S E R V I C E N O T E

54121A Four Channel Test Set**Serial Numbers:** 0000A00000 / 2926A99999**New heatsink required when horizontal board assembly is changed****Duplicate Service Notes:** None**To Be Performed By:** Agilent-Qualified Personnel**Situation:**

Figure 1. New Heatsink Mounting Arrangement

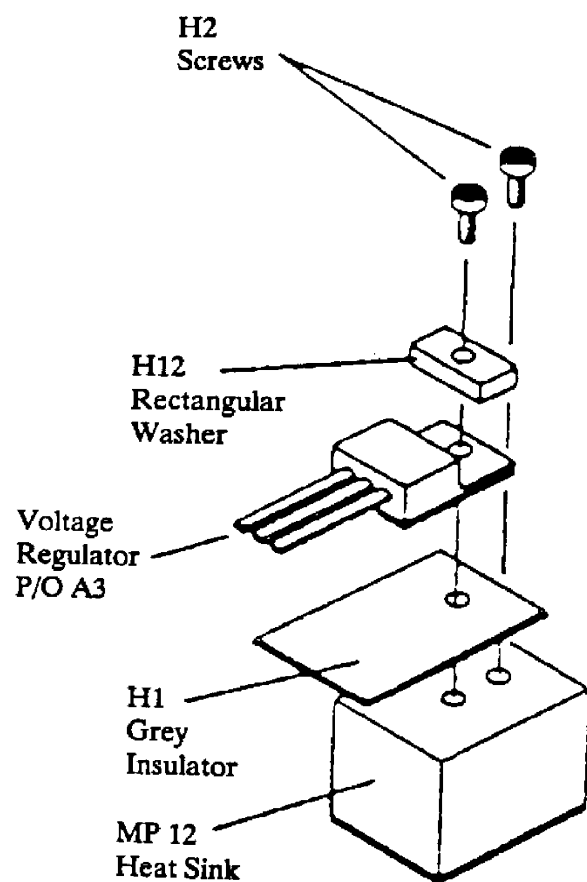
The three terminal regulator A1U26 is now soldered directly into the board assembly which eliminates the regulator socket. This new mounting arrangement requires the new MP12 heatsink that has two tapped holes for mounting. See Figure 1.

A new heatsink MP12 and two new mounting screws are needed when the A1 Horizontal Board Assembly is changed. See Parts Required below.
